## **TAYLOR POINTE SUBDIVISION, UNIT TWO**

This is a request for a one-year extension of a previously approved 50-lot / 20.1± acre subdivision. The subdivision is located at the West terminus of Taylor Pointe Drive.

APPLICATION NUMBER 11 DATE February 4, 2010

# DETAIL SITE PLAN

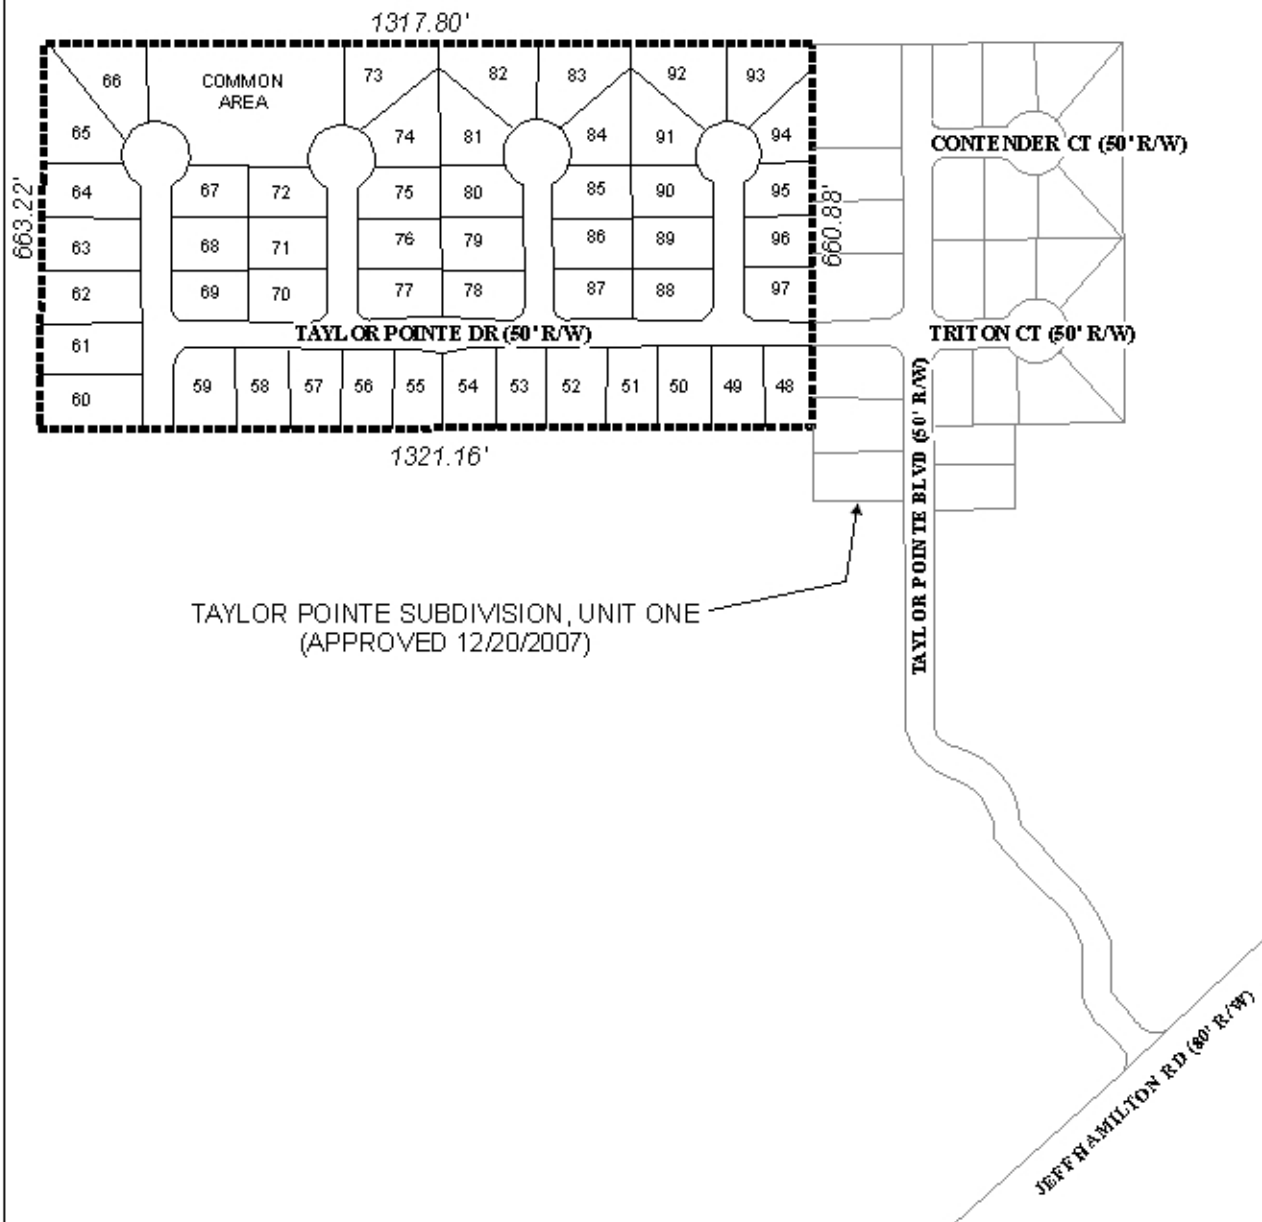
This is the second request for an extension since the subdivision was originally approved in February, 2008. There have been no changes in conditions in the surrounding area that would affect the subdivision as previously approved. However, since the original approval, the Subdivision Regulations have been amended to include the 2003 International Fire Code (IFC) standards for street construction, specifically standards for cul-de-sac diameters. Those standards require cul-de-sacs without a central median to be 120' minimum right-of-way diameter. Since the proposed subdivision contains cul-de-sacs without a central median of 100' diameter, the cul-de-sacs should be revised to 120' diameter to meet the adopted 2003 IFC standard. Roads are not currently under construction within the proposed subdivision.

- 1) revision of the cul-de-sacs right-of-way diameter to 120' to comply with the 2003 International Fire Code standards.
